TO: Eurobodalla Shire Council

Traffic lights at North and Perry Streets intersection

Attachment 1: Detailed discussion of recommendations

Figure 1: an unsignalised T-intersection, like that of Perry and North Streets.

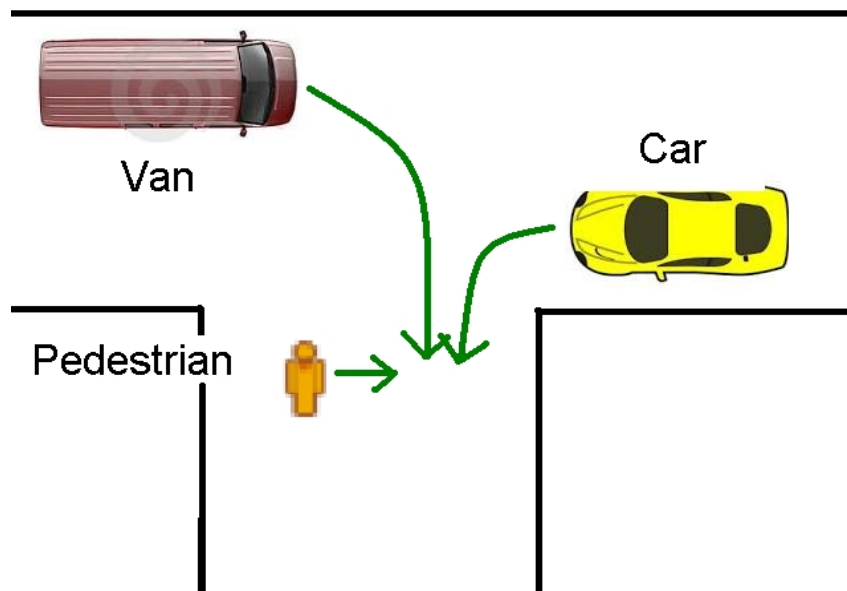
To test knowledge of the road rules, ask yourself and a few friends which of the following

answers is the correct answer to the question, “*who must give way in the circumstances shown in Figure 1 above?*”

- A) The van must give way.
- B) The car must give way.
- C) The pedestrian must give way.
- D) It's a Mexican stand-off. All must give way. Nobody may proceed until the pedestrian and/or a driver waves them through.
- E) The van and the car must both give way.

The correct answer can be found [Road Rule 73](#).
